DEPARTMENT OF TRANSPORTATION
HIGHWAYS DIVISION

ELECTRICAL SYMBOLS

North-South Road <u>Phase 1C</u> F.A.I. Proj. No. STP-8930(4)

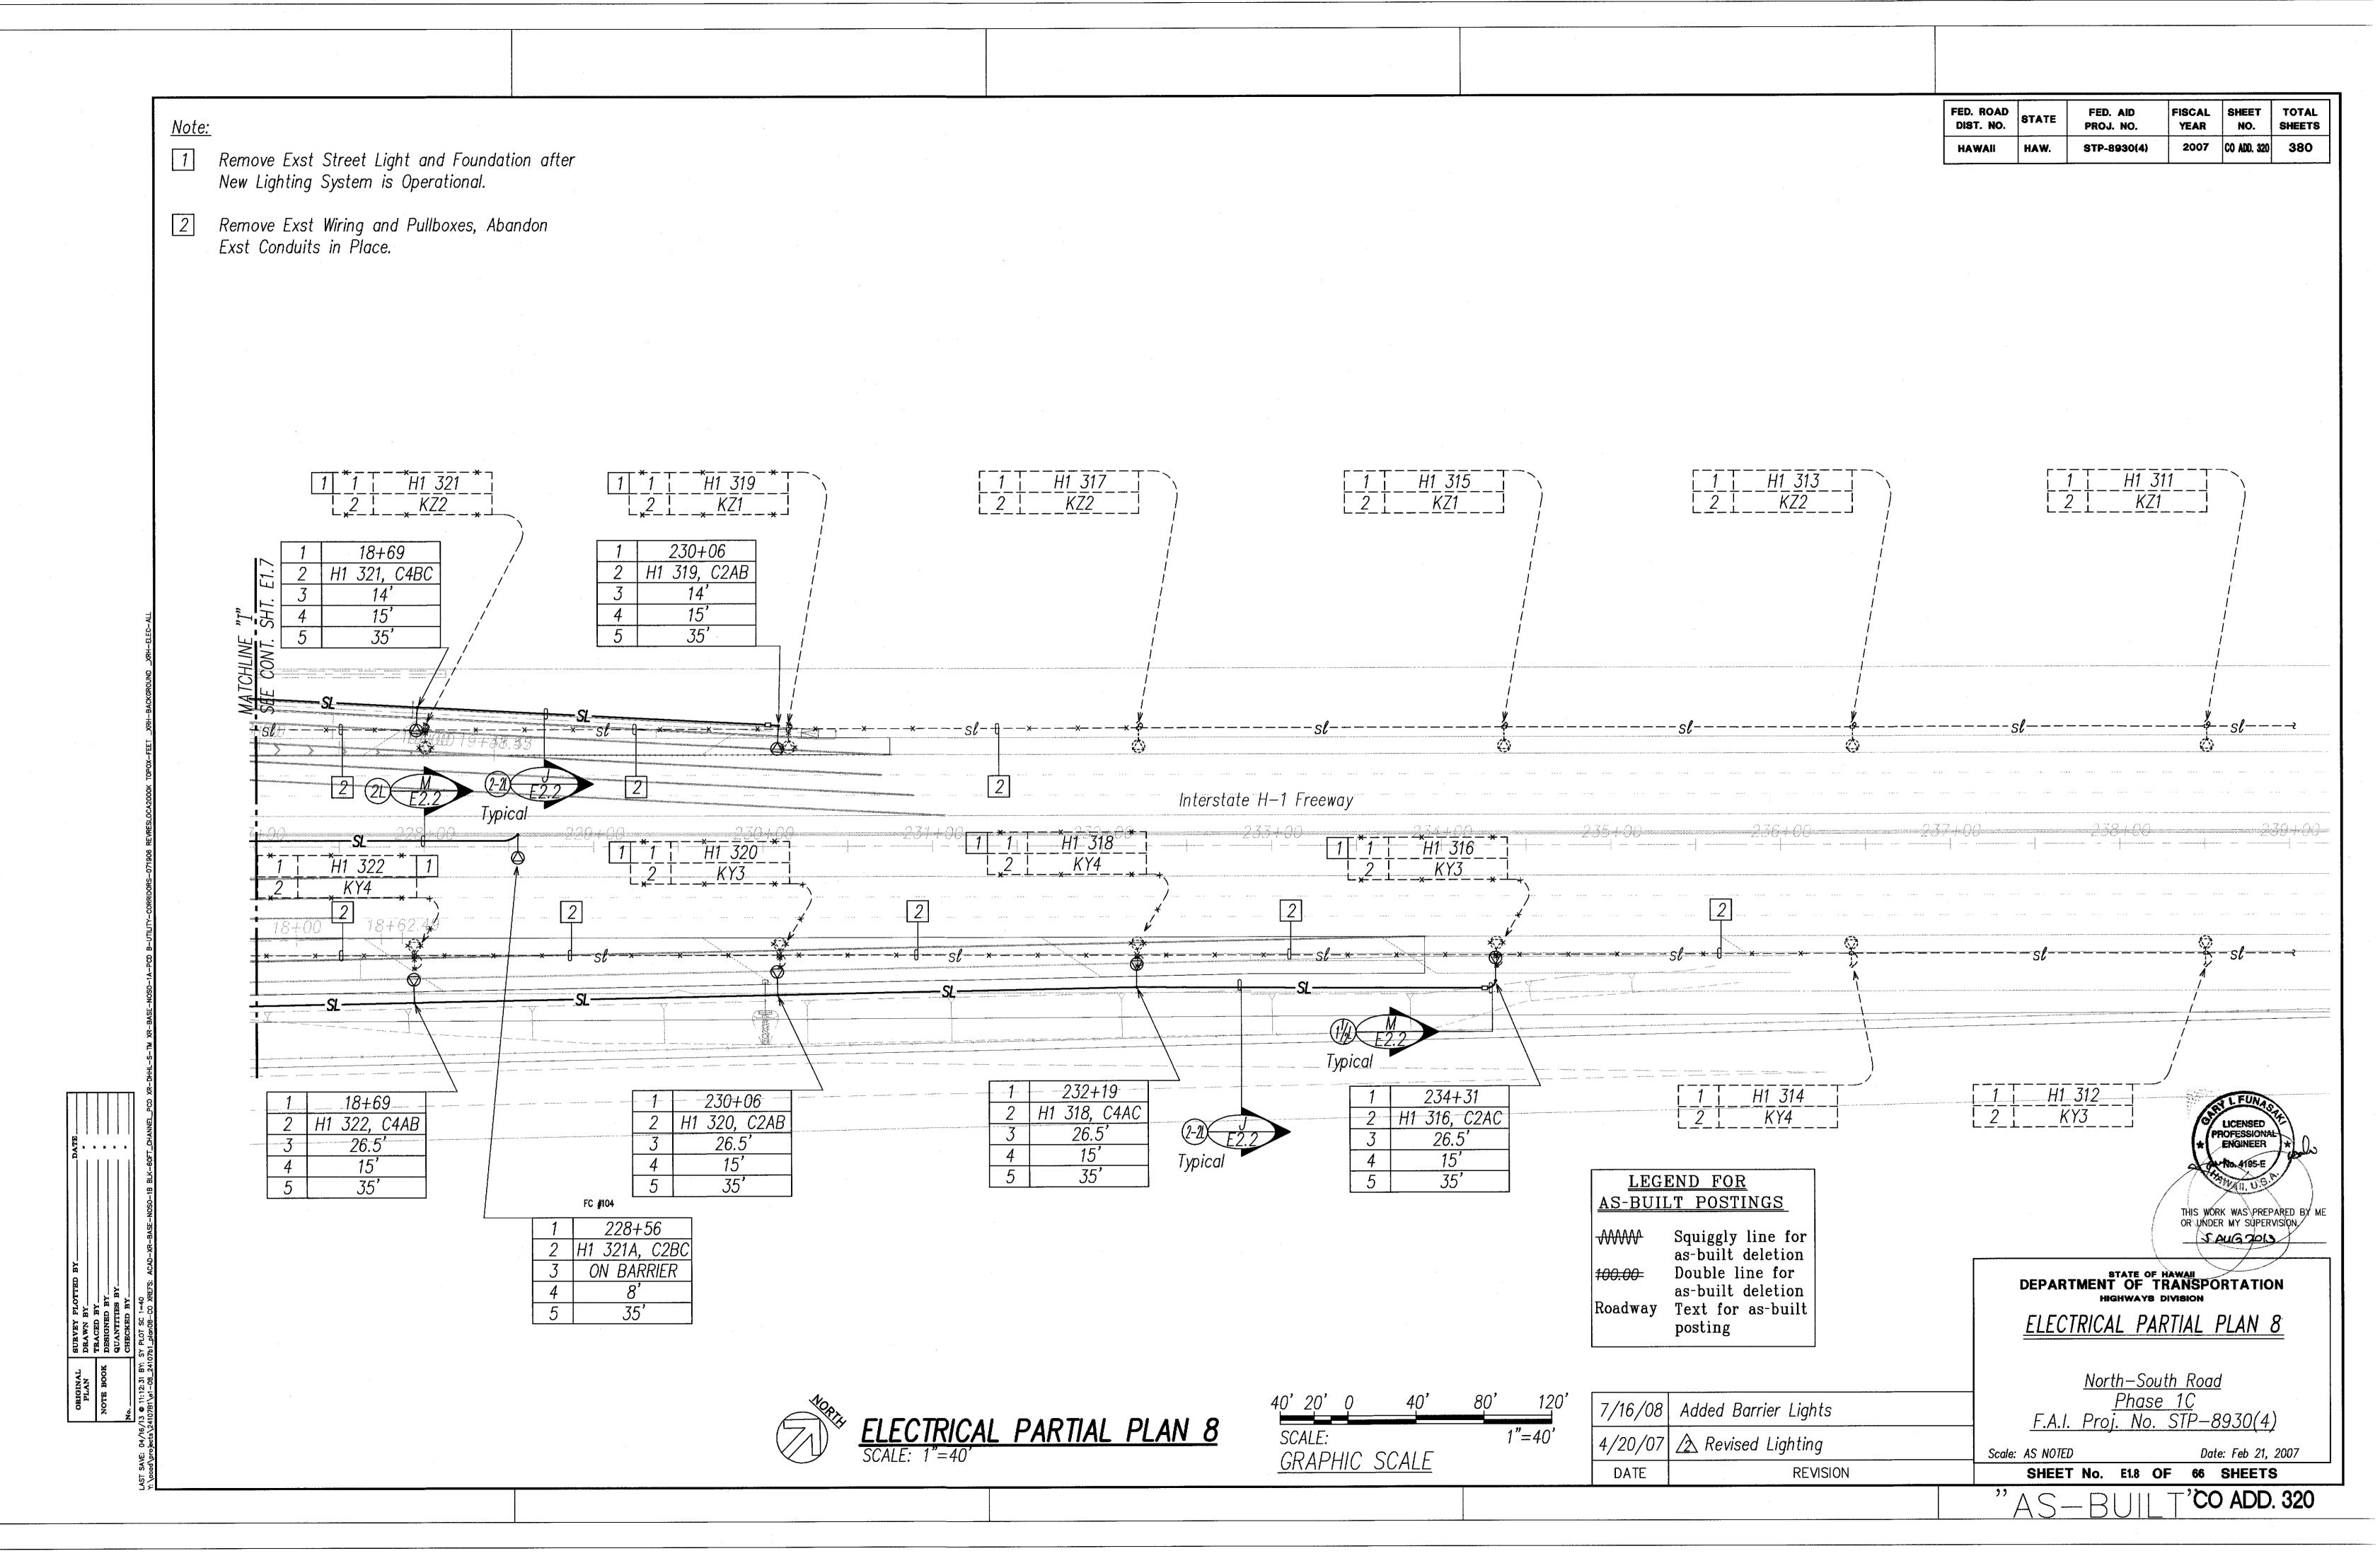
FC #144
TYPE B PULLBOX ELIMINATION ACCEPTABLE © STA 208+14 IF: ALL 3 PHASE OF CIRCUIT C2 SHALL BE EXTENDED INTO THE LIGHT STANDARD TRANSFORMER BASE

• UNCONNECTED PHASE OF CIRCUIT TO BE TERMINATED & CAPPED. RELOCATION OF CABLE SPLICING TO TRANSFORMER BASE OF HWY LIGHT H1 • 2" CONDUIT TO BE ADDED FOR FUTURE CIRCULIT EXTENSION. SPARE CONDUIT TO BE DIRECTED TOWARD PALEHUA BRIDGE, EXTENDING MIN. DISTANCE OF 5' FROM LIGHT STD FOUNDATION. (2-25) (4S) (2P) (2-2E) H1 341\* \_\_\_\_M3\_\_ FED. ROAD FISCAL SHEET TOTAL YEAR NO. SHEETS FED. AID DIST. NO. PROJ. NO. 213+80 211+97 206+39 -MATCHLINE "C" 2007 ADD. 315 380 IIAWAH HAW. STP-8930(4) H1 335, C4AB 2 H1 337, C2AB H1 341, C2BC SEE CONT. SHT. E1.4 H1 343 Remove Exst Street Light and Foundation after New Lighting *35*′ *35*′ 204+54 System is Operational. 2 H1 343, C4AC 2 Remove Exst Wiring and Pullboxes, Abandon Exst Conduits in Place. *35*′ Provide 12 Pr #20 Interconnect Cable \* \* - + - × - instance \*2 Conduist -208+19 131+53 131+53 Provide 3#1, #2 Gnd within (TS). 210+19 2 H1 339A, C2AB REVISED STATION FC #158 210+19 2 NS 33, C4AC **Underpass** NS 34, C2AC 2 H1 340, C2AC Provide 3#4/0, #2 Gnd within (WIM). 2 H1 339, C4AC H1 344 BSW 12<del>9</del>+60 M5 NS 32, C4AC BSW Interstate H-1 Freeway FROM UNDER PASS LIGHTING JUNCTION BOXES, UNDER BRIDGES, H1 335<sup>^</sup> ADJ. HWY = GRS CONDUIT, EXPOSED 204+54 ONDUIT TO BURIED ENCASED (CONCRETE)  $C^*$ CONDUIT = SCH 40 PVC. 2 H1 344, C2BC H1 342\* 206+39 208+19 2 H1 342, C4AB 2 H1 340A, C4BC 1 H1 336\* 2 KY3 \* H1 338 15' 213+80 2 H1 336, C2BC 126+60 128+20/ 1 1 H1 340 / 1/20 -211+97 NS 31, C2AC NS 30, C2AB 128+20 2 H1 338, C4BO M5\_/\* BSW BSW NS 29, C4AB 15 15' BSW TR Ace-141 (Pk Nail) Elev=203.00 35' 0+91 D1/D2, C4AB (-)5+22 C4, C4AC 4+65 D4, C2BC (-)1+14(-)3+50 C1, C2AB C3, C2AC BC 16'/ 35' 2+73 15'/ D3, C4BC 35'/ 126+80 (FC #65: 1ST. SUPPLEMENT) -1+91 O/S 55' (FROM BASELINE) NS 28, C4AB -1-4 126+80 BSW C2, C4AB Exst Palehua Raod 2 NS 27, C2/AB APPROVED BY: BSW/ HAWAIIAN ELECTRIC COMPANY, INC. /35' THIS WORK WAS PREPARED BY ME OR UNDER MY SUPERVISION. LEGEND FOR HAWAIIAN TELCOM AS-BUILT POSTINGS 125+40 DEPARTMENT OF TRANSPORTATION

TYPICAL DUCT SECTIONS III Not to Scale

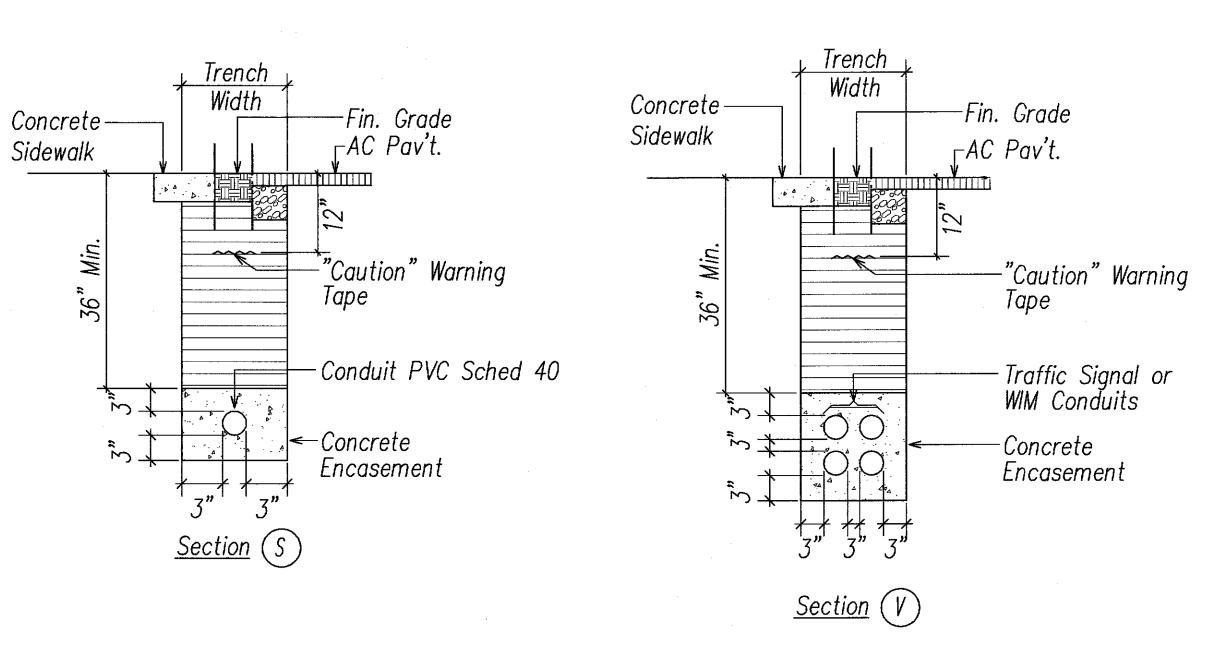
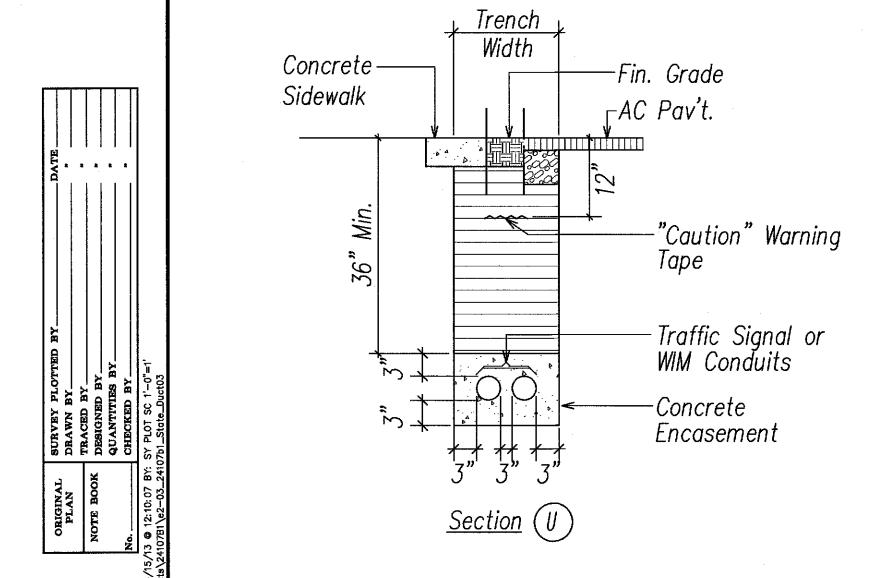
FC #45 \* REPARE OF H-1 PAVEMENT FOR WIM TRENCH CROSSING THE H1 FREEWAY WILL NOT FOLLOW THE TYPICAL DETAILS ON THIS PAGE. REPAIR SHALL CONSIST OF REPLACING FULL PANELS BETWEEN TRANSVERSE JOINTS. OVER THE COMPACTED TRENCH BACKFILL: 11" PCC PAVEMENT13" AGG SUB BASE SEE 'TRANSVERSE CONSTRUCTION JOINT @ EXISTING PCC PAVEMENT' DETAIL ON PG ADD 110 / C4.8
